**Subject:** Response to CEQA Comments on the Great Redwood Trail - Ukiah (Phase 4) – Initial Study and Mitigated Negative Declaration (SCH# 2024081302)

Re: Ukiah Phase 4 review Comments/Questions

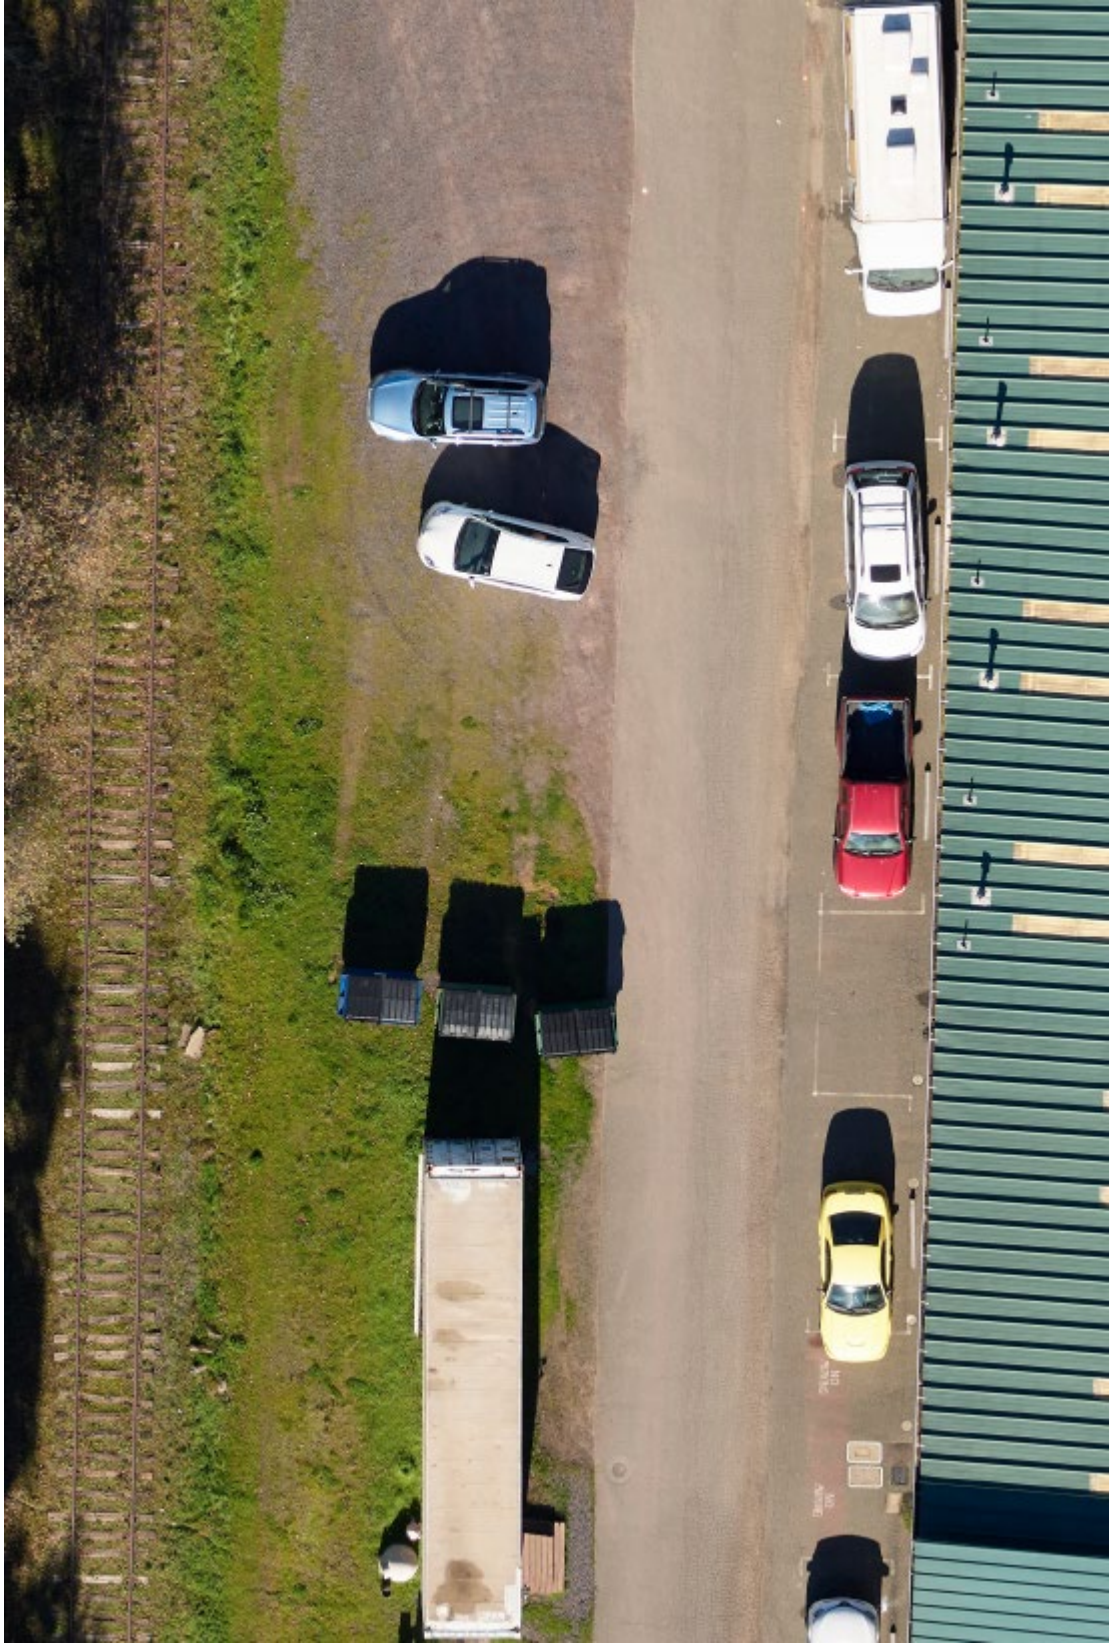
14. *How will the additional 245 ft of encroachments be addressed? There is a well-used dirt roadway assumed for vineyard overlapping the planned trail.*

Below is an overall Google Earth view of the area of encroachment. A detailed series of 6 aerial photos follow showing the 575 ft of encroachments. **The photos start at the north end and overlap going south:**

- All the vineyards in question are owned by the City of Ukiah and all contractors employed at those locations are under contract with the City of Ukiah. The animal shelter is in negotiations to move and the City is in coordination with the County on future use of this property. Project plans do not interrupt current operations of this facility.

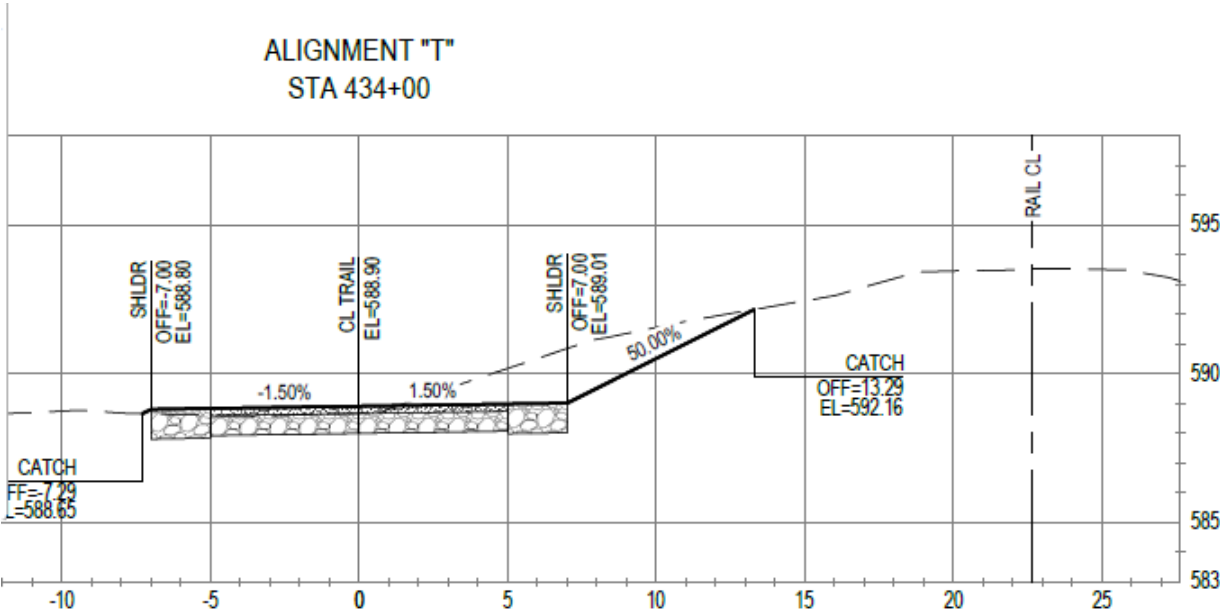
15. *The trail ends at Plant Road. The track crossing at this location is in very poor condition, as is the road itself are there plans to improve these conditions? (see below photo).*

15) The trail ends at Plant Road. The track crossing at this location is in very poor condition, as is the road itself are there plans to improve these conditions? (see below photo).

- This road is outside the project scope and belongs to Mendocino County and not within the City of Ukiah's pavement rehabilitation program. As a terminus to the trail, the project will provide crosswalk striping within the roadway and an ADA ramp for future connections. See sheet C-404.

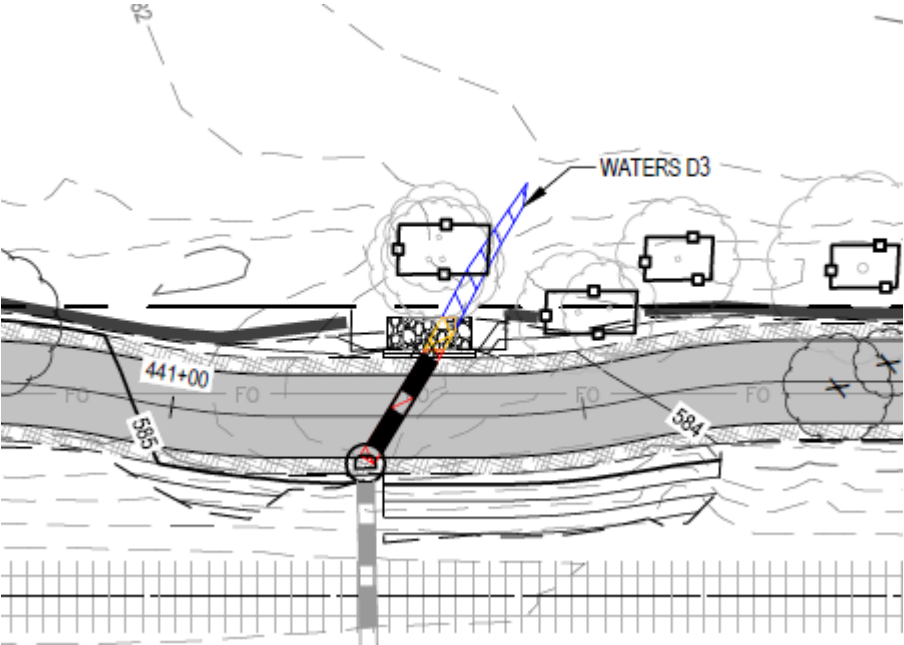
16. *Sheet C-121 and C-122 (“Drainage Plan 1 & 2”) have five plans that indicate the railroad embankment requires regrading at these locations. Cross sections show catch points with line to edge of trail indicating all drainage of RR embankment drains onto trail?*

16) Sheet C-121 and C-122 (“Drainage Plan 1 & 2”) have five plans that indicate the railroad embankment requires regrading at these locations. Cross sections show catch points with line to edge of trail indicating all drainage of RR embankment drains onto trail?

- Any drainage from the RR running across the trail will continue in slope across and off the trail as shown at 1.5%
